Edwin I. Hatch Nuclear Plant
Request to Revise the Plant Service Water Pump Well Minimum Water Level
Response to Request for Additional Information
Regarding Support of Post-Accident Cooling Requirements for 30 Days

**Response to Request for Additional Information
Regarding Support of Post-Accident Cooling Requirements for 30 Days**

Figure 1
Altamaha River Flow Data at Hatch since the Year 2000

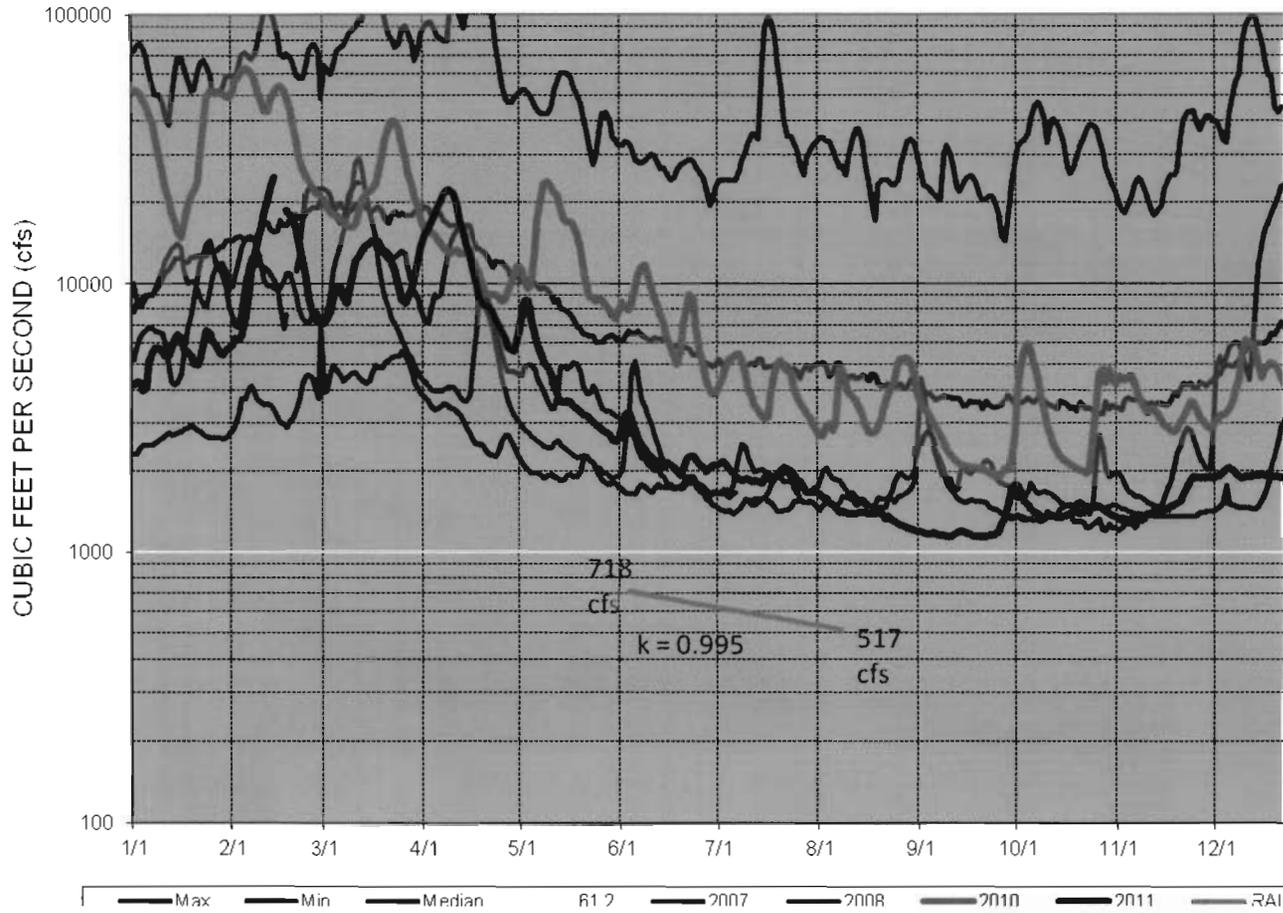
As stated in the license amendment request (LAR), Edwin I. Hatch Nuclear Plant, Units 1 and 2 (HNP 1 and 2), uses a recession formula equation to compute the projected time (in days) for the plant service water (PSW) pump well level to reach 60.0 ft mean sea level (MSL), which is the minimum level required for post-loss-of-coolant-accident cooling requirements as limited by the Standby Service Water Pump. This formula contains a recession constant represented by the letter "k" (also known as depletion factor) which represents the type of flow (surface runoff, interflow, or base flow) that dominates the area being studied. Furthermore, the LAR states that it uses a value of 0.995 (base flow in stream flow is dominant) for the recession constant when using the equation.

However, reference 3 of the LAR states that the overlapping ranges for the selection of "k" values represent the inherent difficulties in identifying a particular recession as being surface runoff, interflow, or base flow. Furthermore, Reference 3 also lists the range for baseflow as being between 0.93 - 0.995 and the LAR states that its baseflow "k" range goes from 0.995 - 0.997.

- a) Please provide additional information on the general process, criteria and analysis that has been used by the licensee in order to determine the recession constant "k" value of 0.995 for the site, with special emphasis on how the aforementioned limitations of Reference 3 were resolved, if applicable. These limitations include, but are not limited to, establishing distinctions between interflow and baseflow, seasonally variable components of baseflow analyzed over a specified period of time, etc.

- a) Please provide a summary of the calculations performed in order to obtain the value of 66 days from Table 2 of the LAR.
- b) Please provide a graphical representation, similar to the example of Figure 3 provided in the LAR, which visually shows the "River Level versus Time" plot using the obtained results from the recession equation and discharge table. This figure should clearly demonstrate the availability of water for 66 days before reaching river level 60.0 ft MSL, as required by the limiting Standby Service Water Pump.

A review of river flow data for the last 12 years supports a value of 0.995 for ‘k’ as demonstrated by the following Figure 1. For each day on the annual timeline the respective maximum flow, median flow, and minimum flow is selected from the river flow data since the year 2000. Figure 1 shows this data graphically with the maximum flow line showing the highest of the high flows for each day and the minimum flow line showing the lowest of the low flows for each day for years 2000 through 2011.

Using data from the minimum flow line over a selected period of days one can solve for the value of ‘k’. Examples of solving for ‘k’ are provided following Figure 1. Example 1 provides the equations (method) for solving for ‘k’ based on river flow. Example 2 demonstrates solving for ‘k’ using two points that are 30 days apart from the minimum flow line on Figure 1. Example 3 demonstrates solving for ‘k’ using the river flows interpolated from the SNC July 5, 2012 LAR Enclosure 1 Table 2 for PSW pump well water levels of 60.5 ft MSL and 60.0 ft MSL, specifically 718 cfs and 517 cfs (see the SNC response to NRC question 3a for the basis for these water levels and flows). Both examples 2 and 3 show that using 0.995 for ‘k’ is supported by the historical river flow data.

- 1) $Q_t = Q_0 \times k^t$
 $Q_t/Q_0 = k^t$
 $\text{Log}(Q_t/Q_0) = t \times \text{Log } k$
 $\text{Log}(Q_t/Q_0)/t = \text{Log } k$
 $10^{\text{Log}(Q_t/Q_0)/t} = 10^{\text{Log } k}$
 $10^{\text{Log}(Q_t/Q_0)/t} = k$
- 2) Solving for 'k' using two points 30 days apart from the minimum flow line on Figure 1:

$Q_0 = 1650$ cfs June 4 point from minimum flow line
 $Q_t = 1400$ cfs July 4 point from minimum flow line
 $t = 30$ days

$$1400 = 1650 \times k^{30}$$
$$1400/1650 = k^{30}$$
$$\text{Log}(1400/1650) = -0.071356 = 30 \times \text{Log } k$$
$$\text{Log}(1400/1650)/30 = -0.00238 = \text{Log } k$$
$$10^{\text{Log}(1400/1650)/30} = 10^{-0.00238} = k$$

0.99454 = k

- 3) Solving for 'k' using the river flows interpolated from SNC July 5, 2012 LAR Enclosure 1 Table 2 for 60.5 ft MSL and 60.0 ft MSL, specifically 718 cfs and 517 cfs. Please reference the line labeled RAI on Figure 1.

The distinction between interflow and baseflow is determined by a graphical review of the historical river flow data in Figure 1, specifically looking for a change in slope of the minimum flow line. Based on the graphical review, flows above 2000 cfs are generally considered interflow and flows below 2000 cfs are considered baseflow. However, the distinction of interflow vs. baseflow is not relevant to a conservative demonstration of being able to support post-accident cooling requirements for 30 days. Use of a 'k' value appropriately supported by river flow data is technically justified.

- b) Since the recession formula is expressed in terms of river flows, please reference the line labeled RAI on Figure 1 for the requested graphical representation using the results from the recession formula and Table 2.
